TO ALL BIDDERS: Renovations of the Library on the Kemper Campus
Boonslick Regional Library – Cooper County Branch

Item No. MEP1 – CHANGE – RE-ISSUE ALL PLUMBING SHEETS

1 LOWER LEVEL PLUMBING DEMOLITION PLAN SCALE: 1/4" = 1'-0"

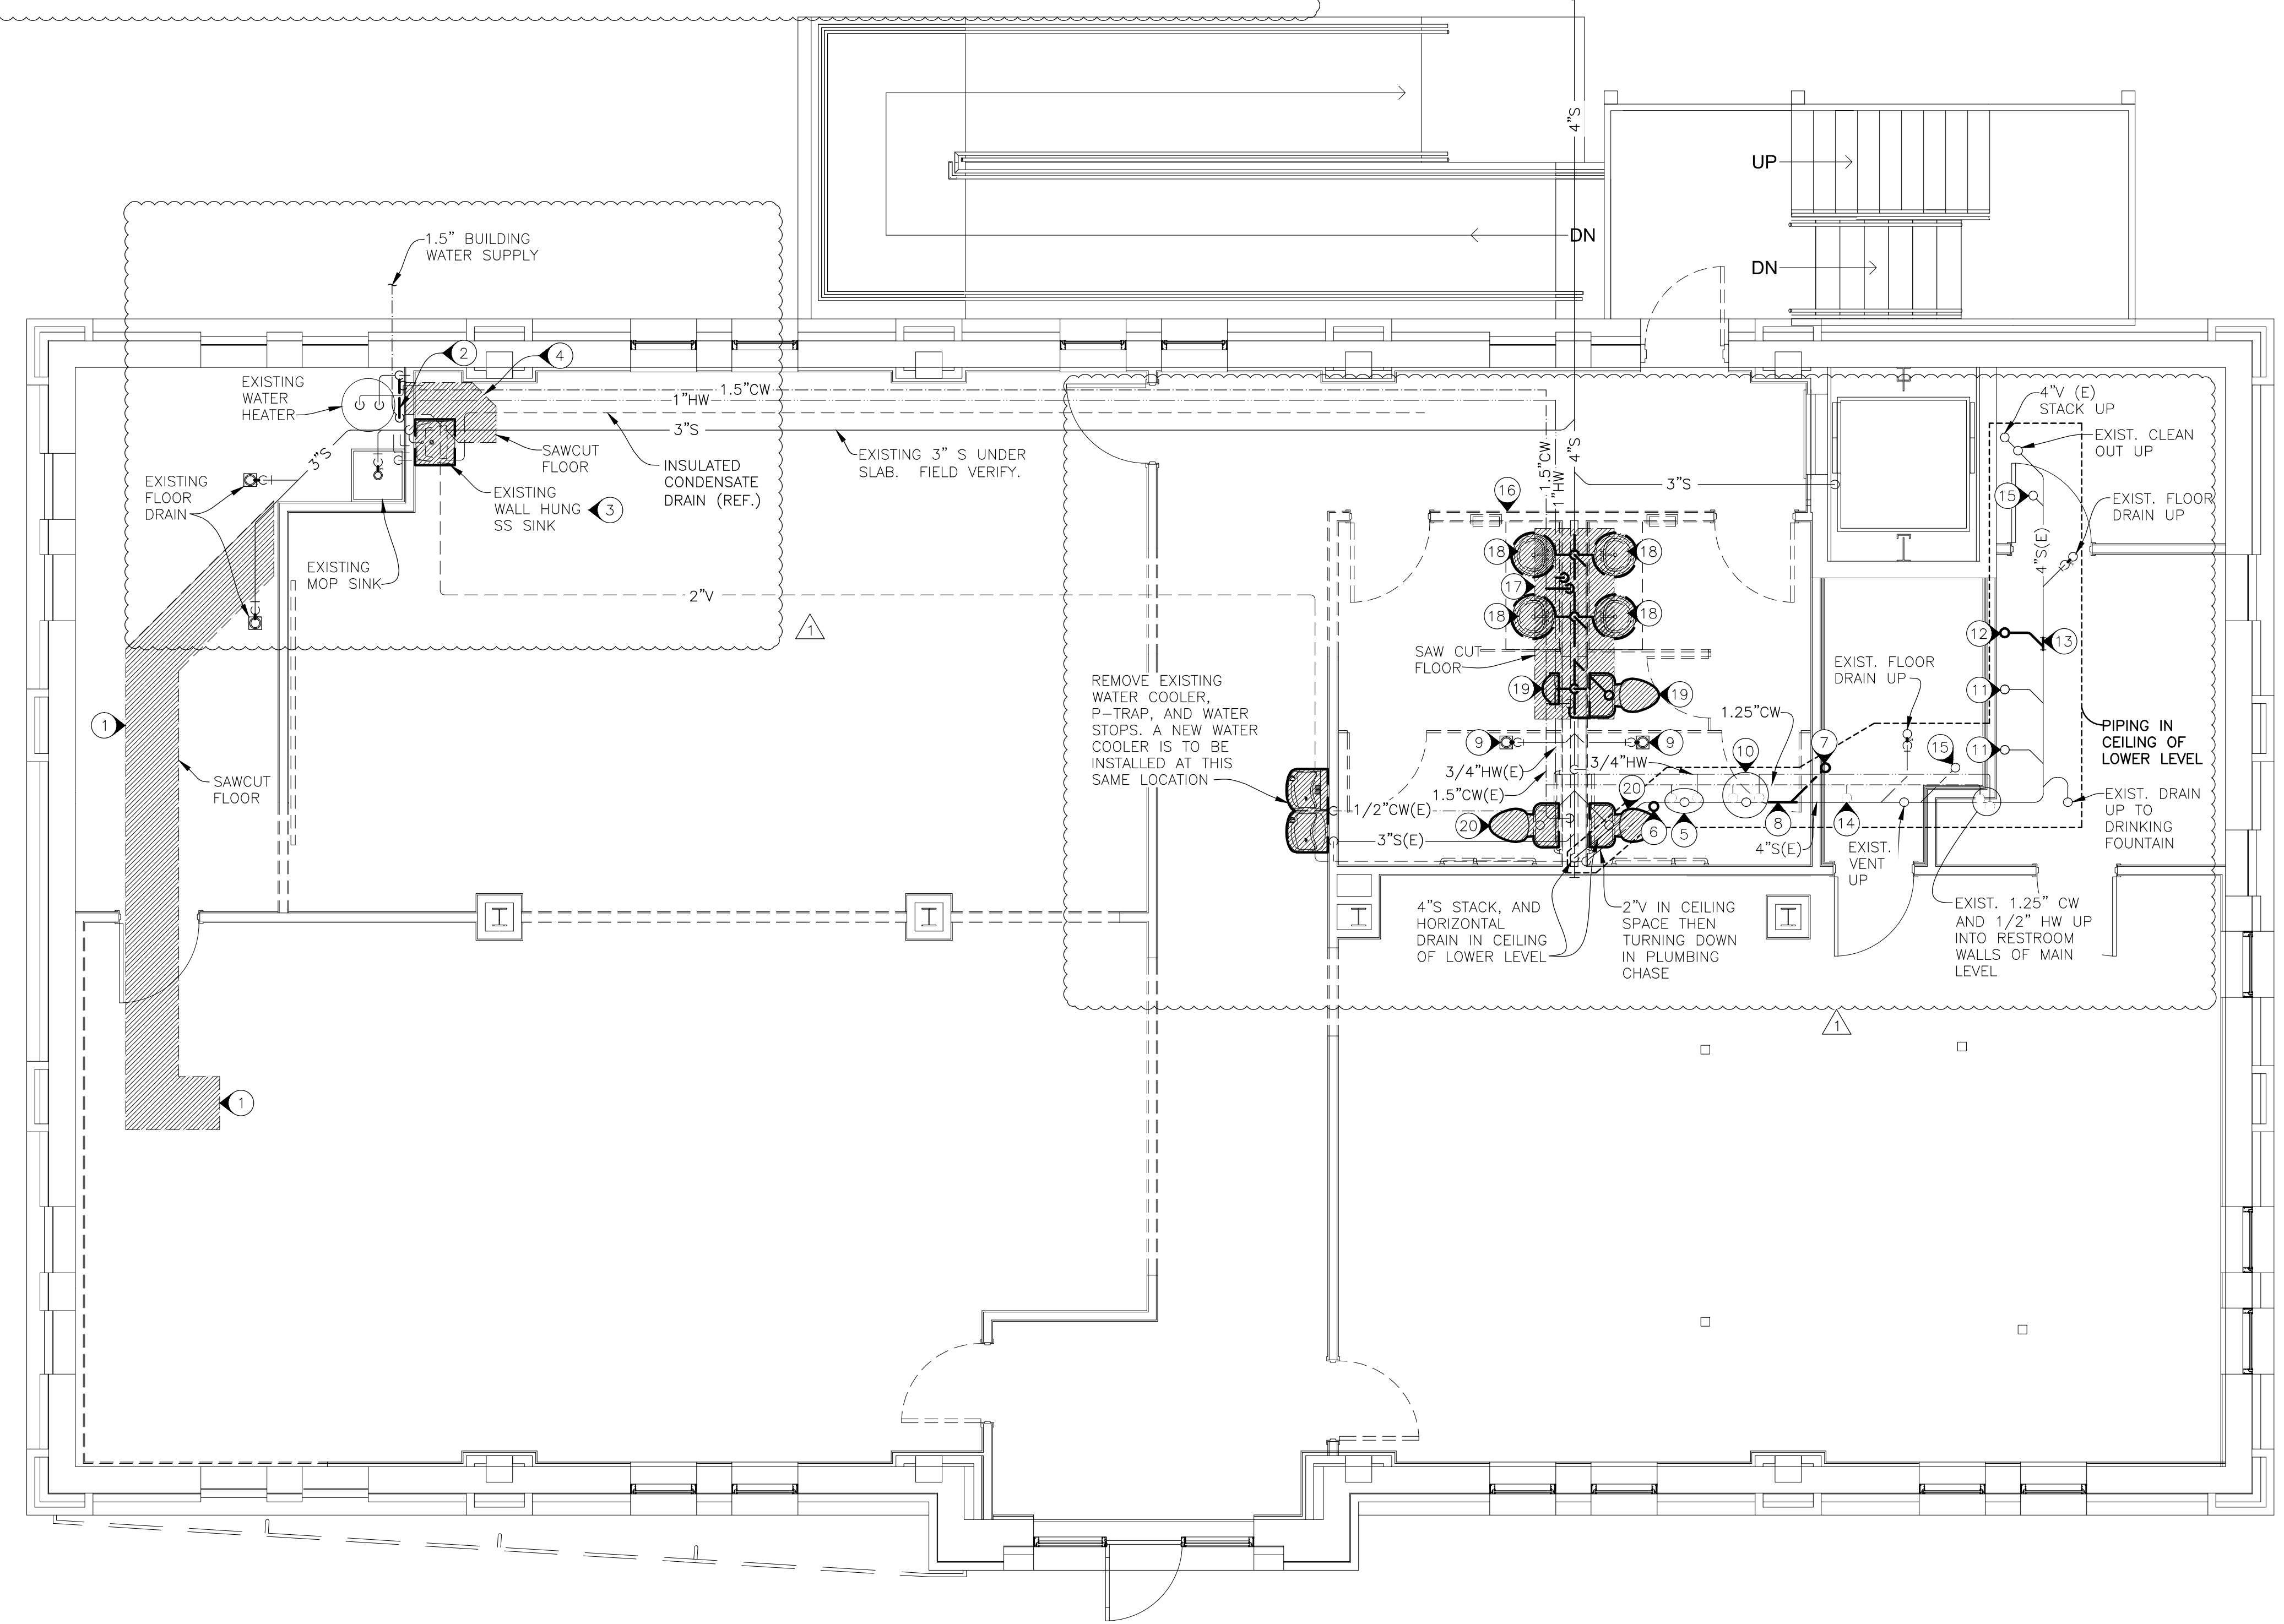
- 1) Additional notes have been added and / or modified.

1 MAIN LEVEL PLUMBING DEMOLITION PLAN
SCALE: 1/4"=1'-0"

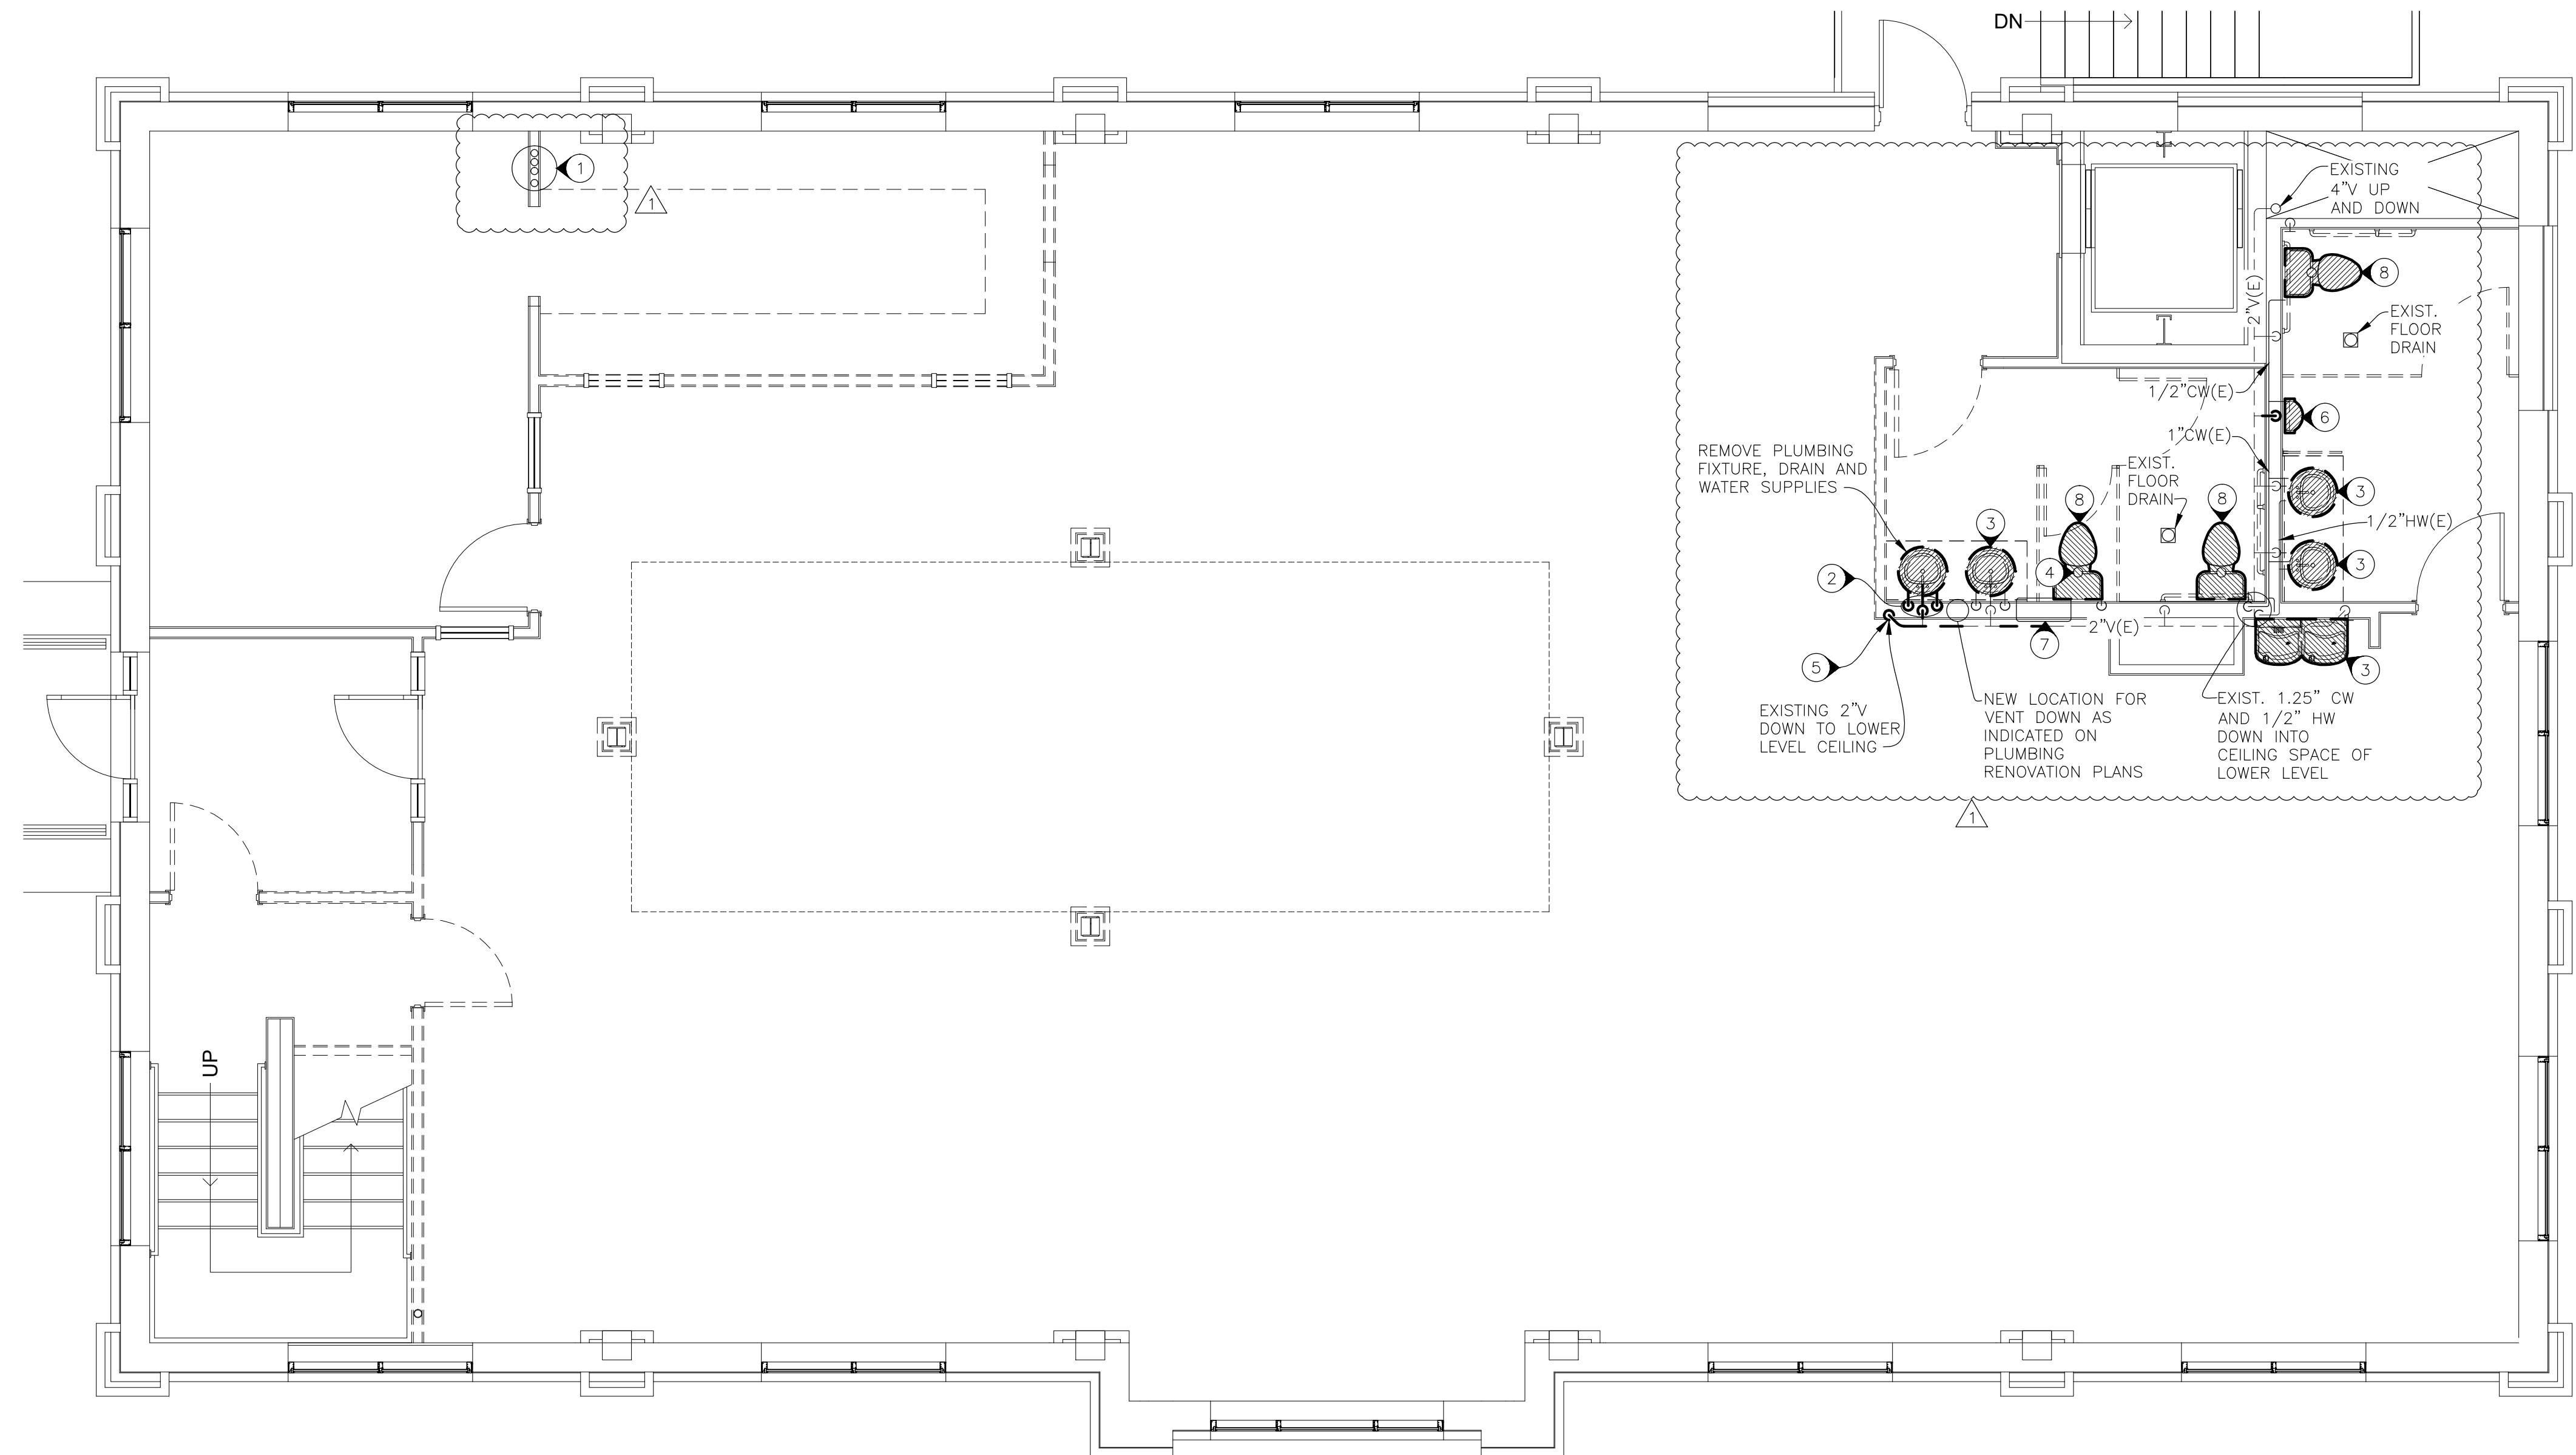
- 1) Additional notes have been added and / or modified.

1 LOWER LEVEL PLUMBING RENOVATION PLAN
SCALE: 1/4" = 1'-0"

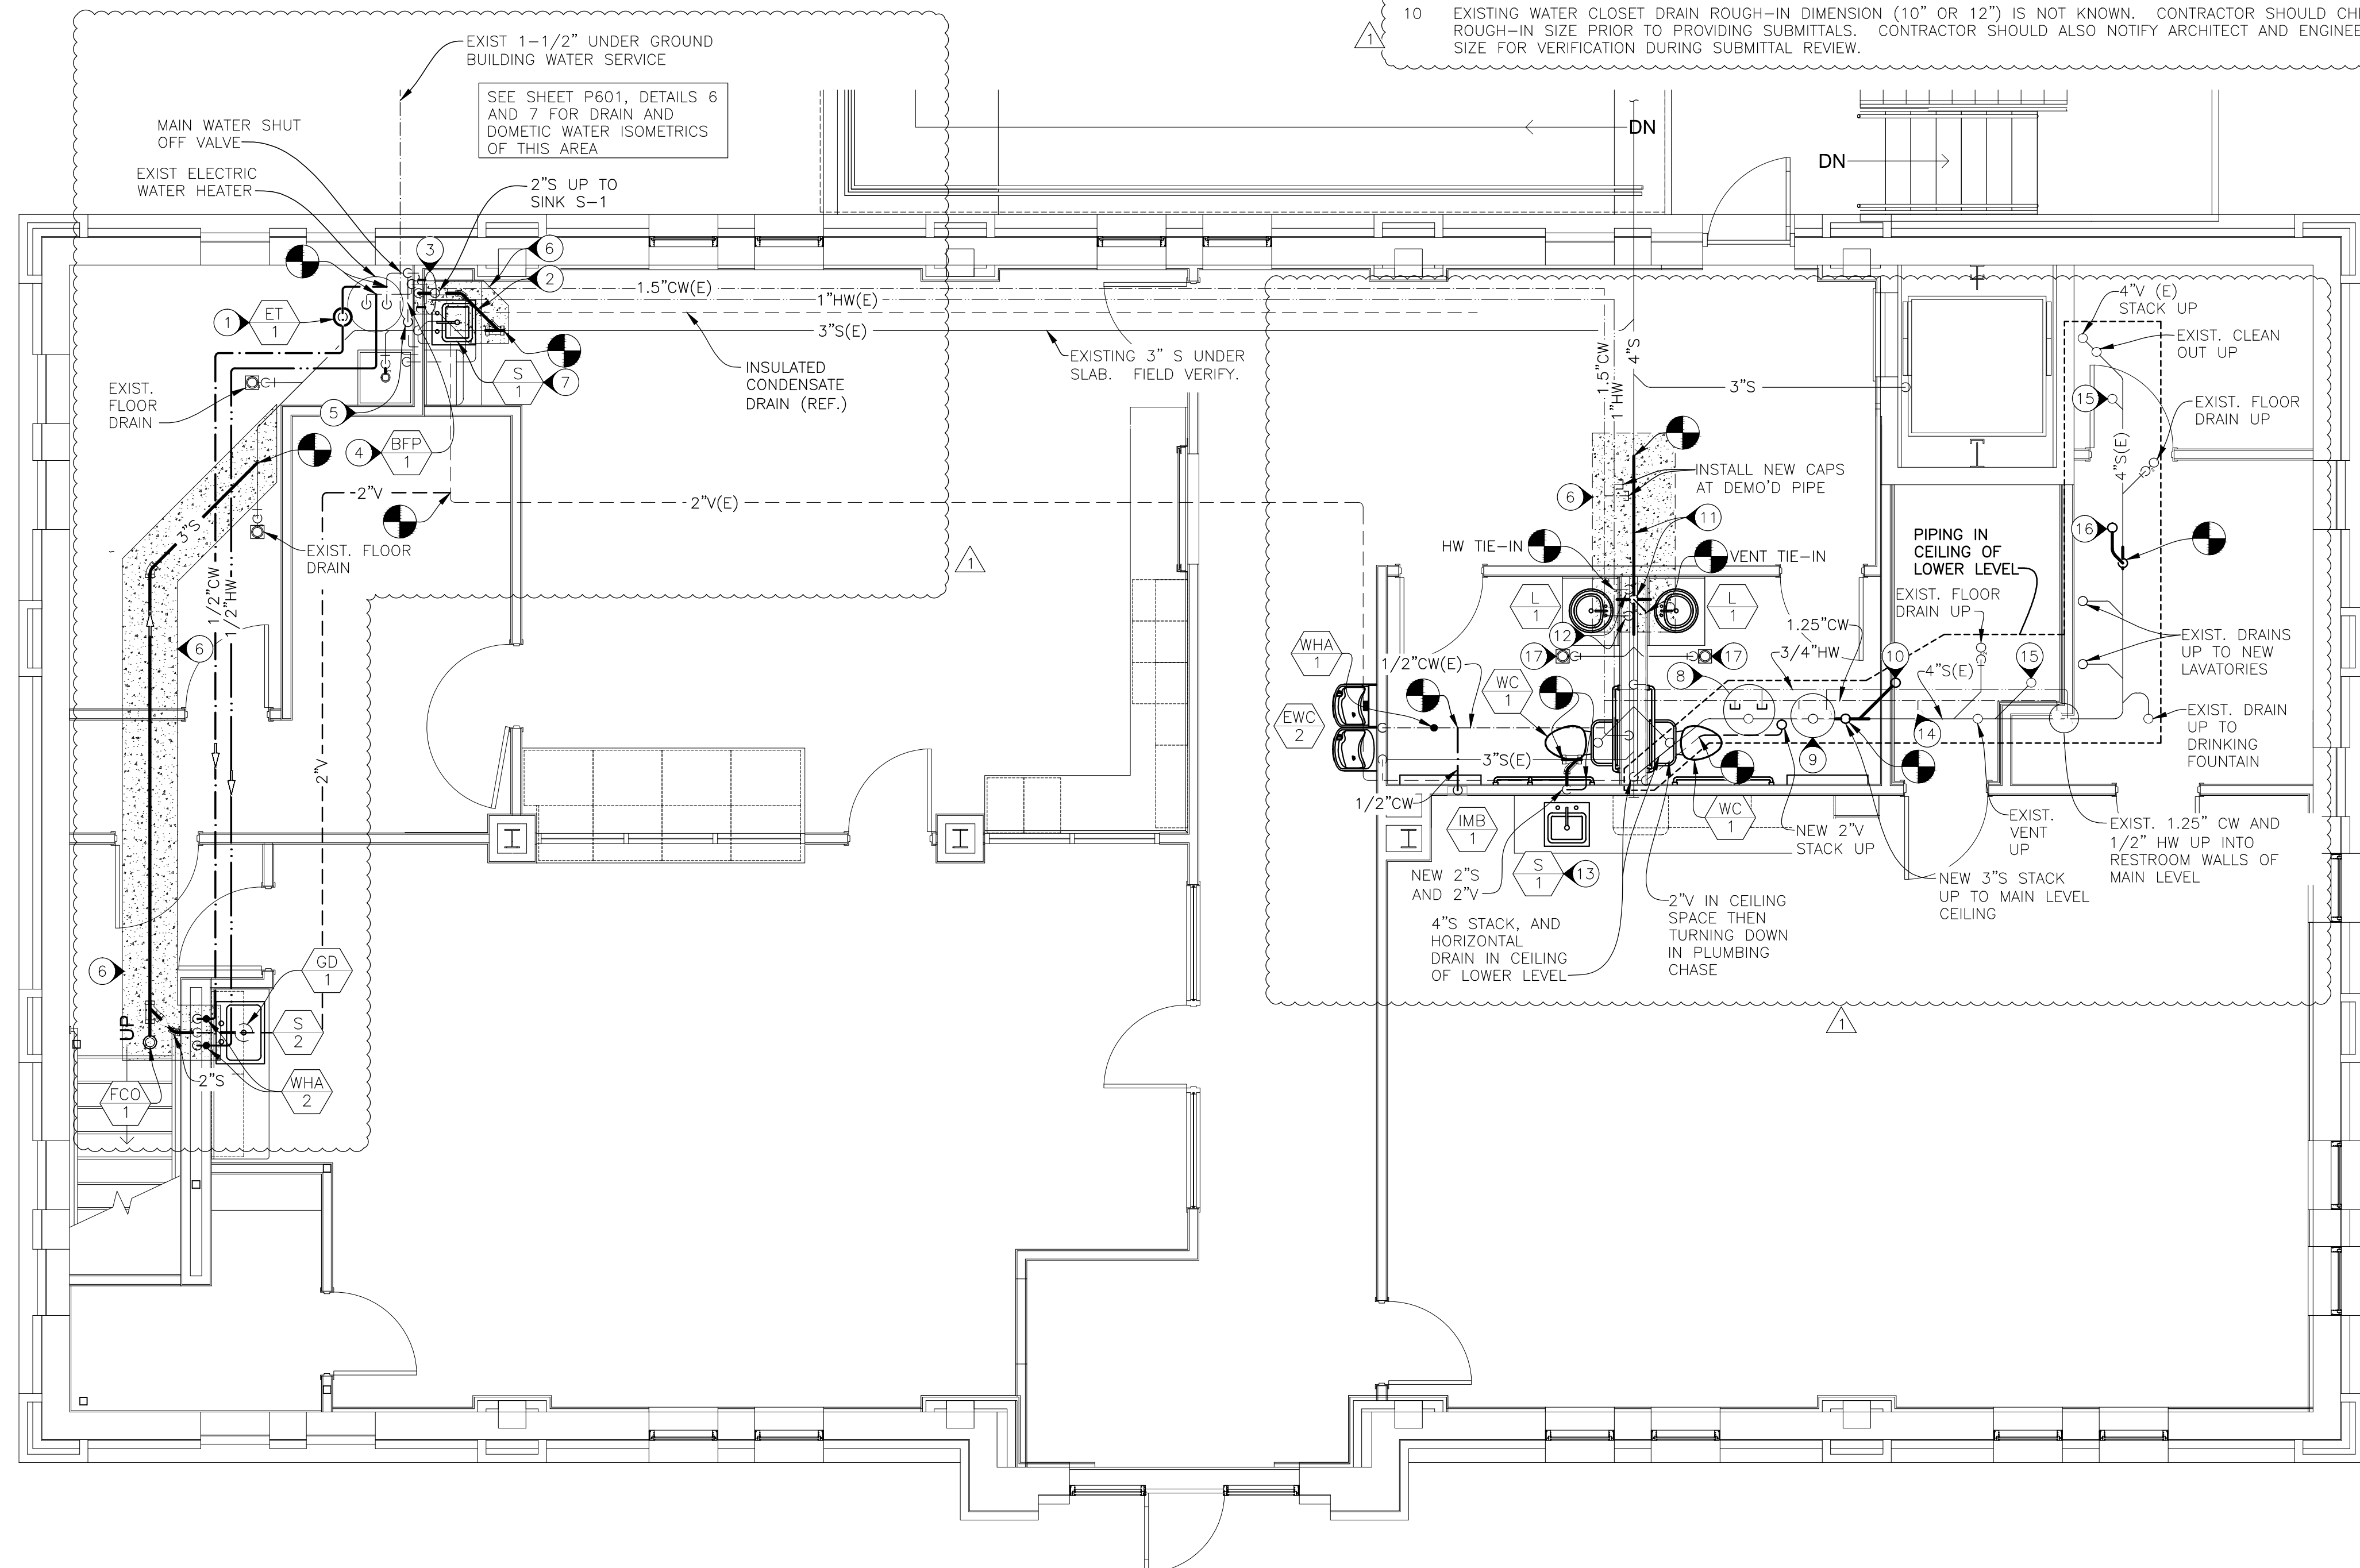
- 1) Additional notes have been added and / or modified.
